**In the Drawings:**

Permission is requested to substitute corrected Fig. 5 in place of original Fig. 5 which is corrected as follows:

Fig.5

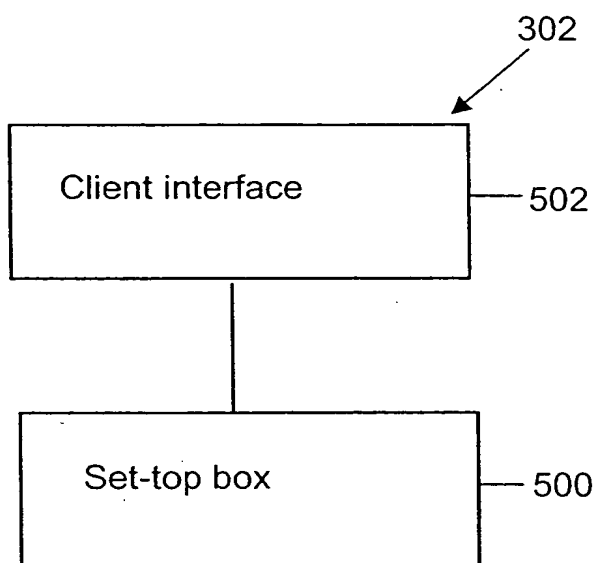
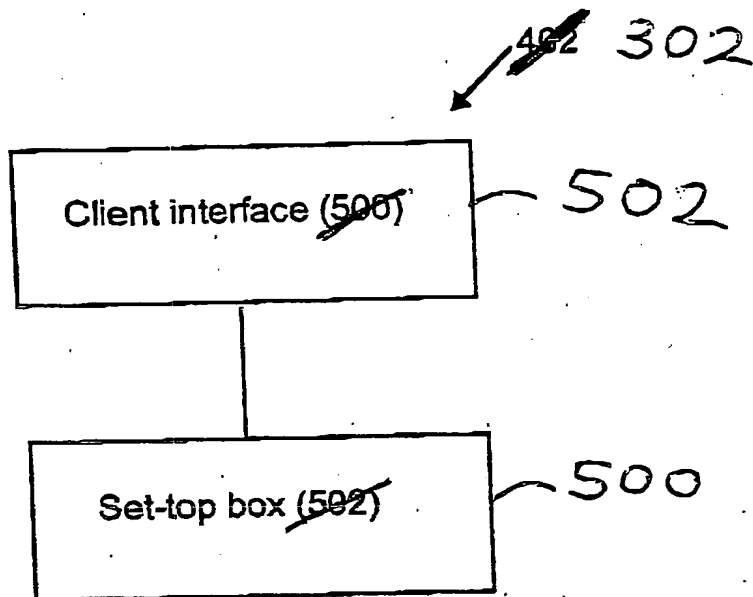
(1) No. 402 has been corrected to 302

(2) "Client interface (500)" in the box has been corrected to 'Client interface';  
correct No. 502 has been entered outside the box.

(3) "Set-top box (502)" in the box has been corrected to 'Set-top box';  
correct No. 500 has been entered outside the box.
